# Access Compliance Report

## Public Rights-of-Way

### (Pedestrian Signals)

Intersection ID: N/A	Main Street:	Cross Street: N/A	Location: N/A
ADA ID: FF953ADFB37E	Signal Type: One Push Button-Non APS	Overall Compliance: No	Severity Score: BTN 1: N/A BTN 2: N/A No BTN: N/A
Codes/Mitigation Info/Possible Solution		Field Measurements/Component Compliance

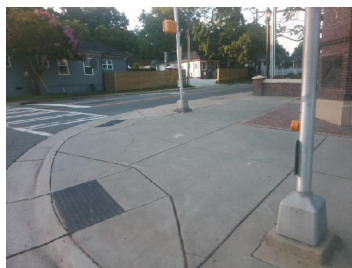
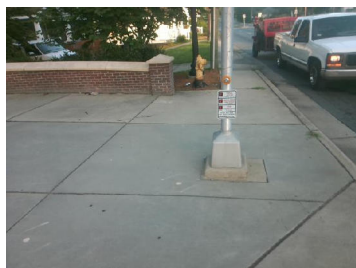
Surveyor Notes: TEXT HT 1/2

PROW/ADA: R410.6, R404.2, R404.3, R406.2

Possible Solutions: Remove & Replace Sign. Provide Push Button Extension. Remove and Replace Clear Space.
